UNITED STATES  
NUCLEAR REGULATORY COMMISSION  
WASHINGTON, D. C. 20555

BROWNS FERRY NUCLEAR PLANT, UNIT 2

AMENDMENT TO FACILITY OPERATING LICENSE

Amendment No. 85  
License No. DPR-52

Figure 3.5.K-1  
MCPR Limits

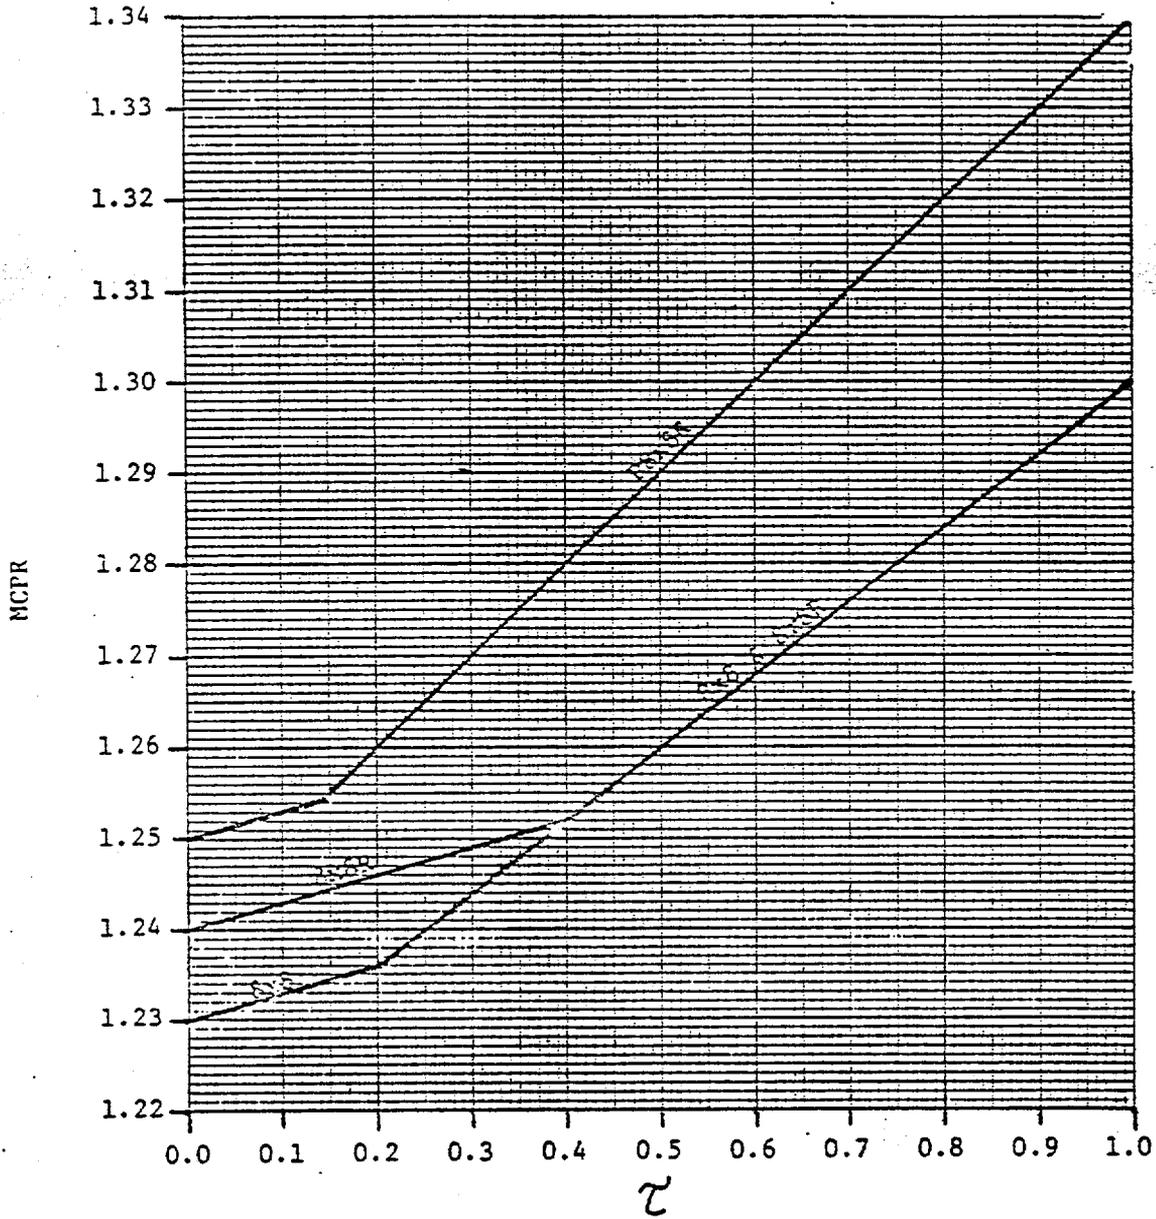
This is the first reload for BF-2 for which the overpressurization transients were analyzed with the ODYN code. Specification 3.5.k and Surveillance Requirement 4.5.k have been revised to reflect the new analyses. This procedure, which was previously reviewed and found acceptable by the staff, is being introduced on all operating BWRs and therefore, is acceptable for BF-2.

The minimum critical power ratio (MCPR) as a function of scram time and core flow, shall be equal to or greater than shown in Figure 3.5.K-1 multiplied by the  $K_f$  shown in Figure 3.5.2, where:
